**1.4 615 WARRIGAL ROAD, ASHWOOD
USE AND DEVELOPMENT OF THE LAND FOR OFFICES, RESIDENTIAL HOTEL,
SERVICED APARTMENTS, DWELLINGS, AND RETAIL PREMISES UP TO 10 STOREYS
IN HEIGHT
(TPA/49377)**

EXECUTIVE SUMMARY:

Figure 3 – Proposed conditional changes to Building A massing

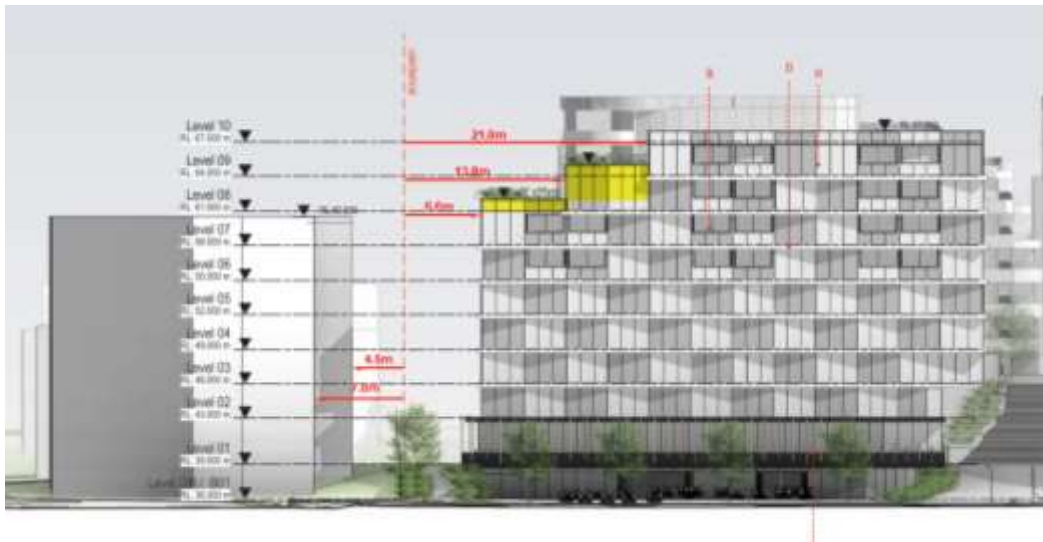
To lessen bulk impacts to the adjoining property to the north, a proposed condition will require the two northernmost apartments on Level 07, Building A to be deleted to increase setbacks to the northern boundary of the site. Any balcony areas on the level above are to be reconfigured to be set back at least the setback provided on Level 07. This will bring the building height at the northern end, comparative to the height of the existing building, and will increase the set back of the level above from approximately 13.8 metres, to 21 metres. This will in turn also improve daylight access to these existing south facing windows.

The proposed condition is illustrated in the figure below. The plan is showing Building A as presented to Warrigal Road.
